UNITED STATES
DEPARTMENT OF THE INTERIOR
BUREAU OF LAND MANAGEMENTFORM APPROVED
OMB NO. 1004-0135
Expires: July 31, 2010**SUNDRY NOTICES AND REPORTS ON WELLS**
*Do not use this form for proposals to drill or to re-enter an abandoned well. Use form 3160-3 (APD) for such proposals.*5 Lease Serial No
NMLC060329

☒ Oil Well ☐ Gas Well ☐ Other2. Name of Operator
CONOCOPHILLIPS COMPANYContact: BRIAN MAIORINO
E-Mail: brian.d.maiorino@conocophillips.com8. Well Name and No.
EMERALD FEDERAL 129 API Well No
30-025-40358-00-X13a Address
3300 N "A" ST BLDG 6
MIDLAND, TX 797053b Phone No (include area code)
Ph: 432-688-691310 Field and Pool, or Exploratory
MALJAMAR YESO W-

ConocoPhillips Company respectfully request to change the BOP and choke manifold design for teh Precision 194 Drilling Rig.

**Emerald Federal 12
ConocoPhillips Company
30-025-40358
February 24, 2012
Conditions of Approval**

CHOKE MANIFOLD ARRANGEMENT

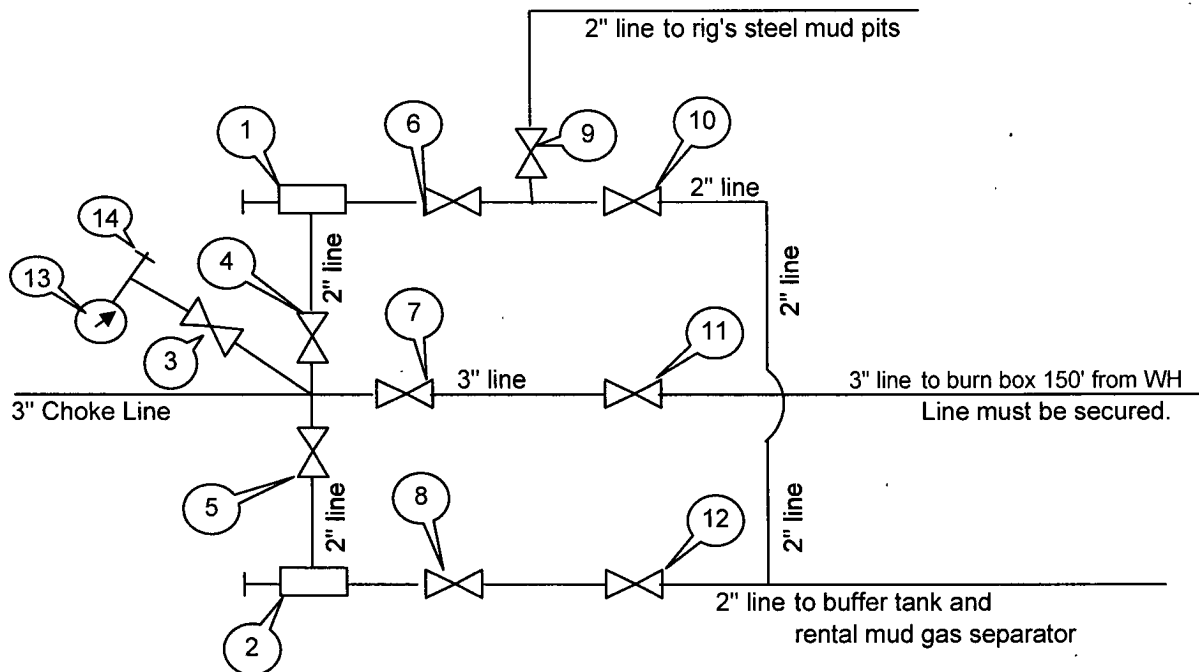
We will test each valve to 3000 psi from the upstream side.

This request is approved. ConocoPhillips has voluntarily arranged communication discussions and a meeting with the BLM to review the requirements of Onshore Order 2 concerning BOPE and related piping. BLM-CFO Engineering and P.E.T. staff have been fully involved in these BOPE reviews, and with the applications of Onshore Order 2 in that regard.

ConocoPhillips, and their rig contractor, have modified the manifold rig piping to achieve approved compliance with the Onshore Orders and their cooperation in this regard is appreciated.
